Re: Response to Peer Review Comments 3

DEP File #: 322-1000 Notice of Intent Application

113-115 Boston Post Road

Wayland, Massachusetts

GRADING DRAINAGE AND UTILITY PLAN

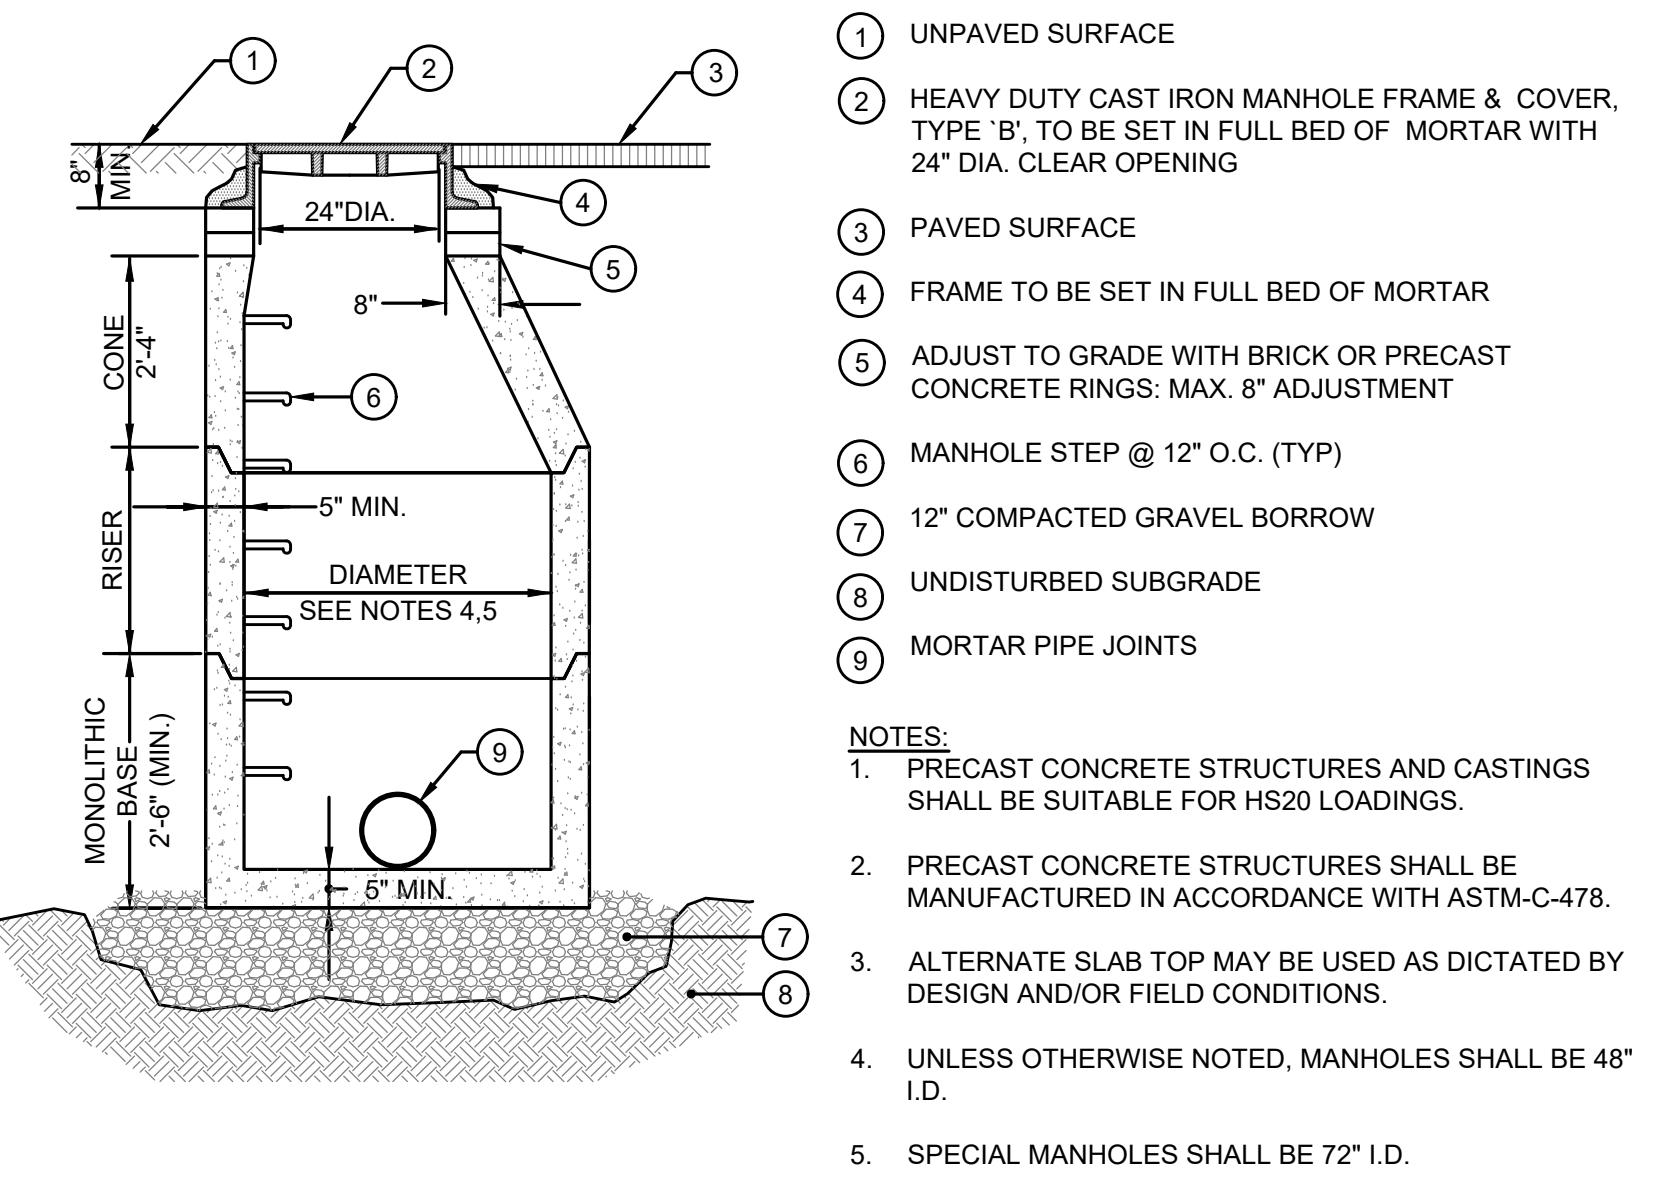
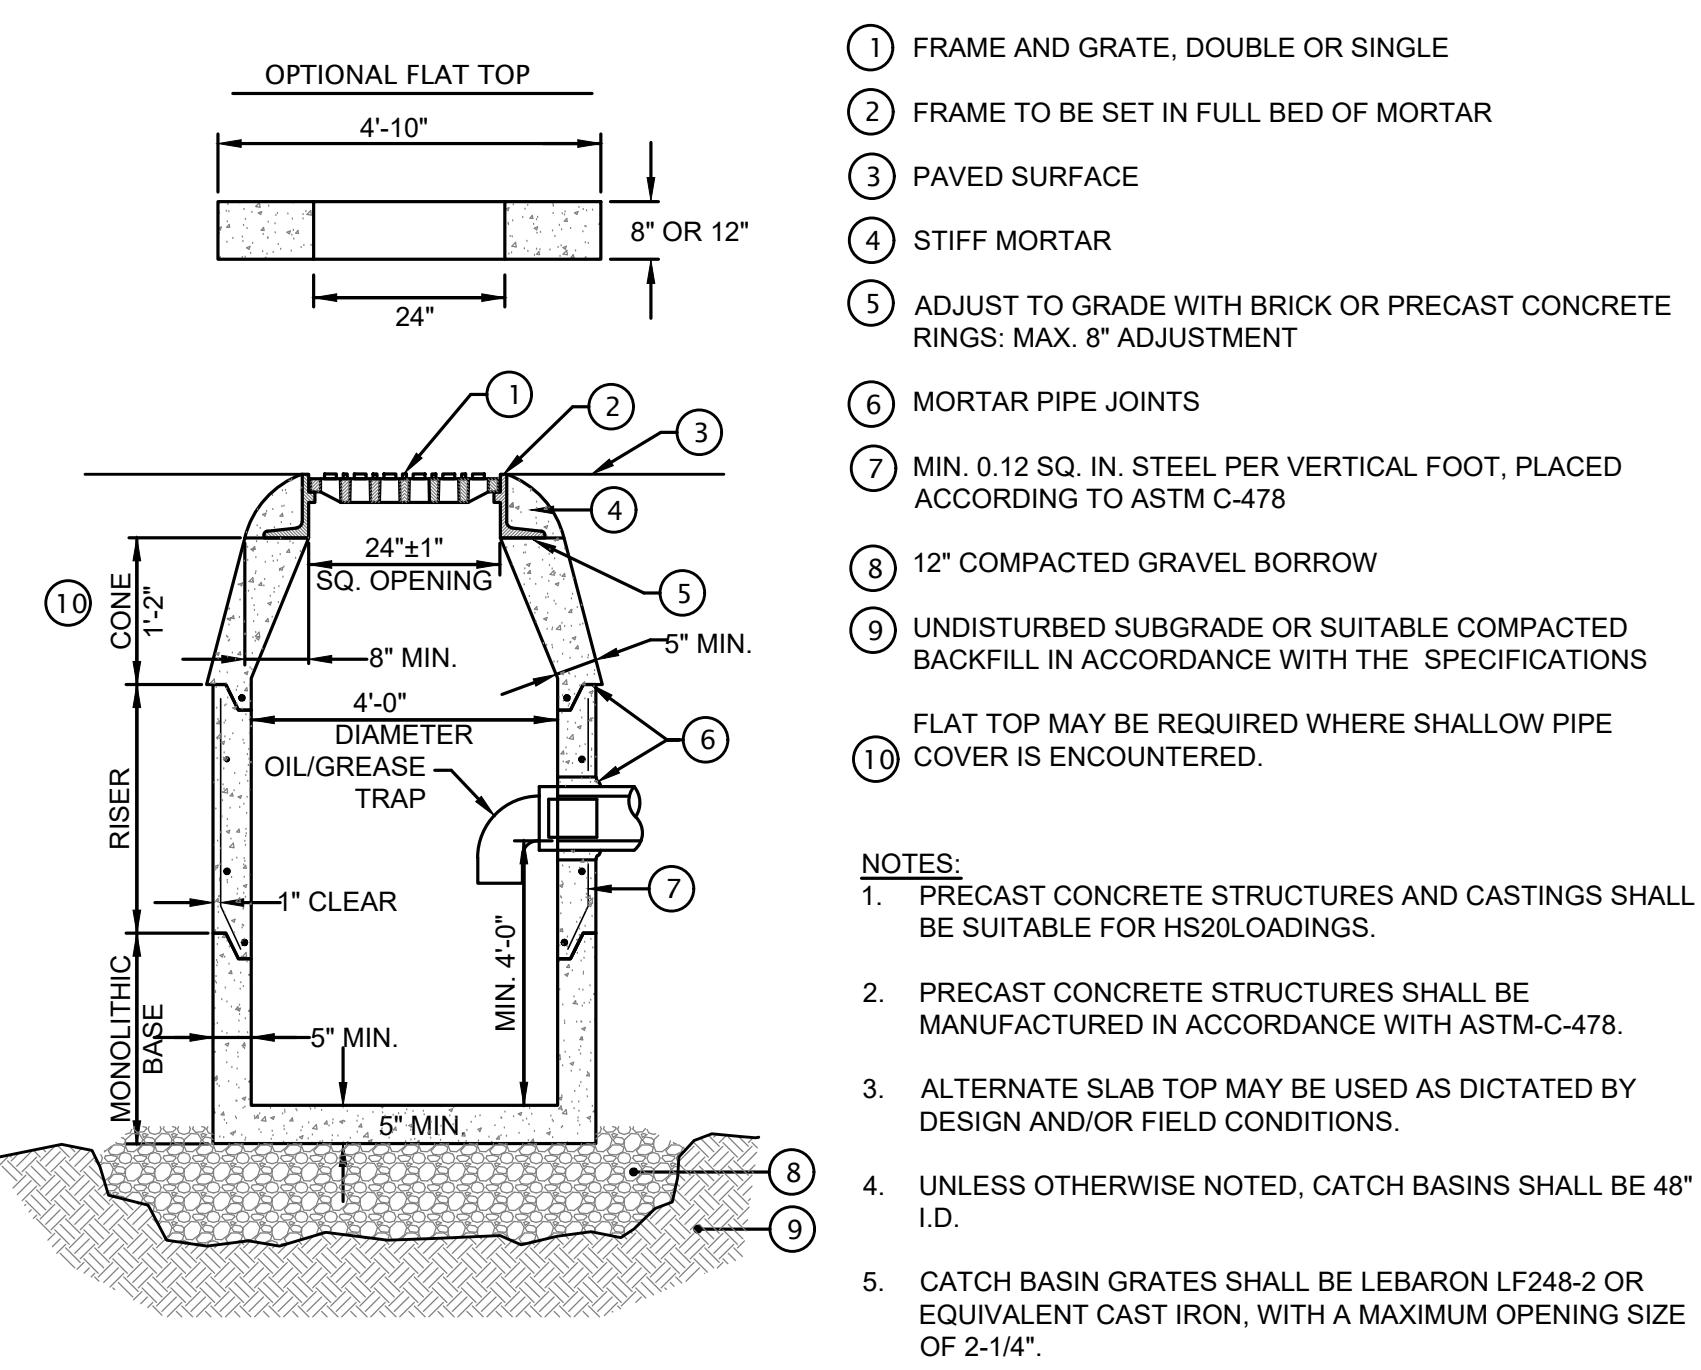
There are not enough grades shown on the Grading Sheet (C-1.0) to show that the runoff from the pavement on the east side of the building will be collected by the basins.

BETA 6/5 Comment: *The grades as shown are incorrect. The rim elevation for CB 302 is 175.3, which is higher than the grade as shown at elevation 174.5+. Comment remains.*

BETA 9/6 Comment: *The proposed rim elevation has been corrected to Elevation 174.30; however, the outlet pipe is a 12" HDPE culvert at invert elevation 173.0. Based upon the elevations, this structure*

cannot be built as shown. Based upon the inverts at DMH 351, it appears that the invert could be dropped to Elevation 172.27 which would provide the cover depth needed for the piping. This should be corrected.

C1.0 5/3 Response: Grades have been adjusted and a note has been added that walk and parking lot drain to CB #302.

C1.0 7/11 Response: The elevation has been corrected.

C1.0 10/31 Response: The elevation has been changed to 172.27.

OVERFLOW BERM AND BASIN CROSS SECTION

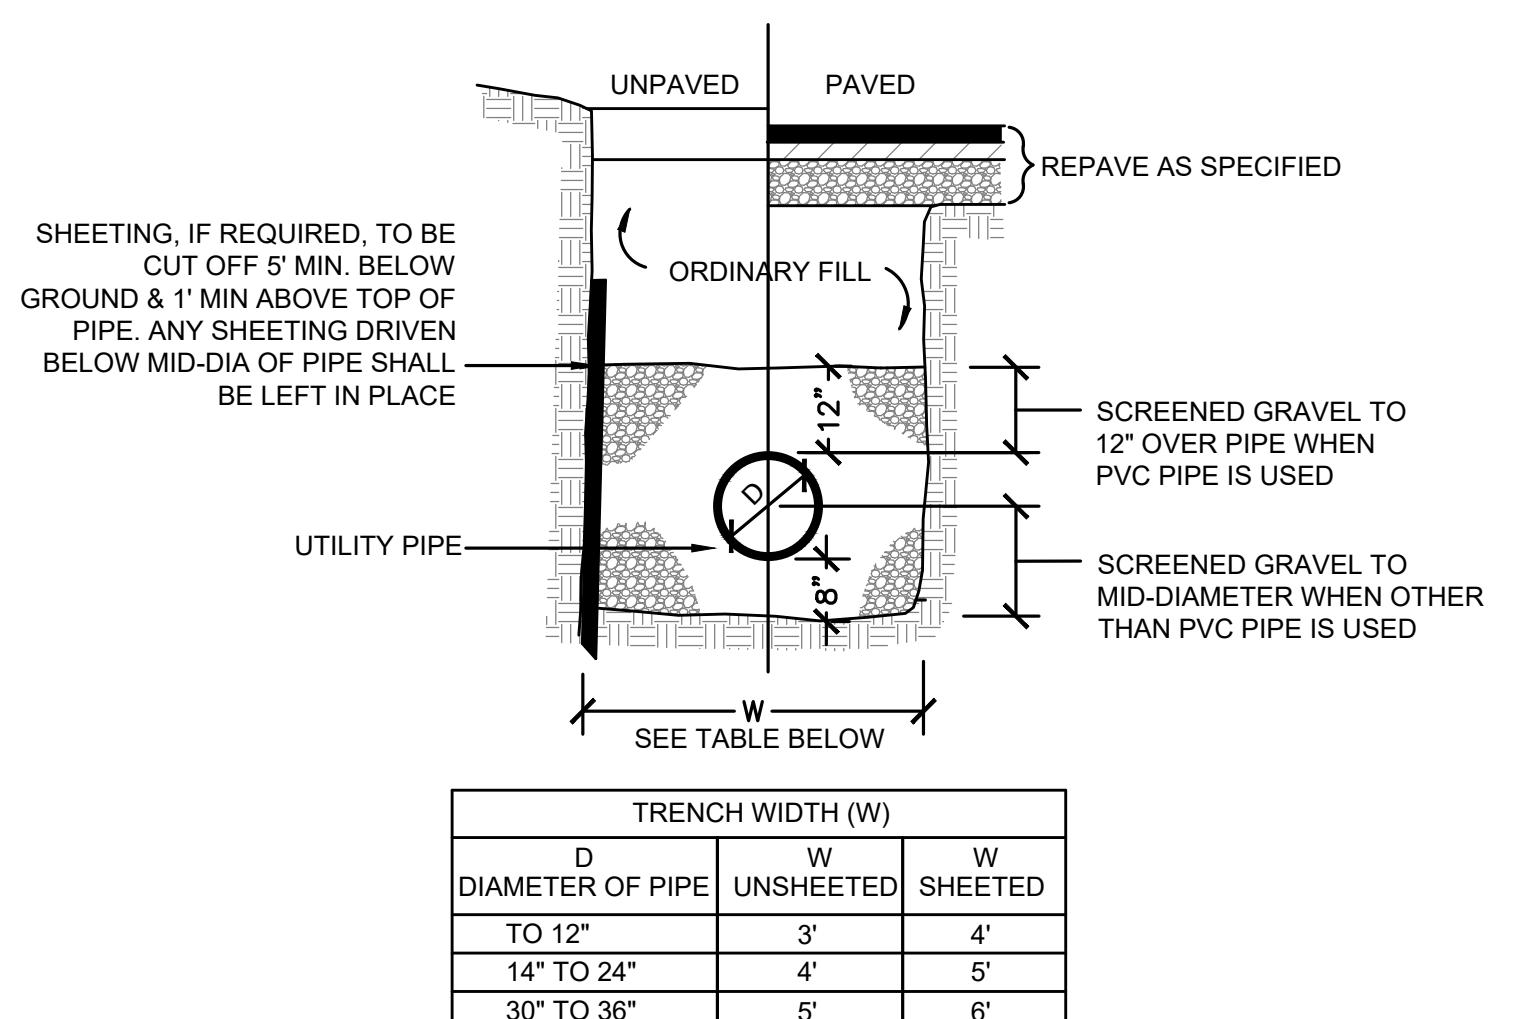
There are no details provided for the proposed infiltration basin embankments. Provide a detail for this structure including crest width, material, gradient of side slopes, surface treatment, spillway design, and general material requirements.

BETA 6/5 Comment: *More dimensional detail is required to define this embankment including crest elevation, crest width, depth and limits of fill removal, replacement material specifications, and bottom material type and depth.*

BETA 96/ Response: *The detail does not match the plan view. In addition, the crest width of the embankment is not identified. Ideally, a width of 8' should be provided. Comment Remains.*

C1.0 5/3 Response: A detail has been added that illustrates the cross section of the basin embankment and the spillway.

C1.0 7/11 Response: Additional detail has been added to the plan.

C1.0 10/31 Response: The stormwater basin is located immediately adjacent to a parking lot where it can be easily accessed for maintenance. The stormwater basin is relatively shallow, measuring up to two feet deep, which will allow for adequate access by foot or machine for maintenance.
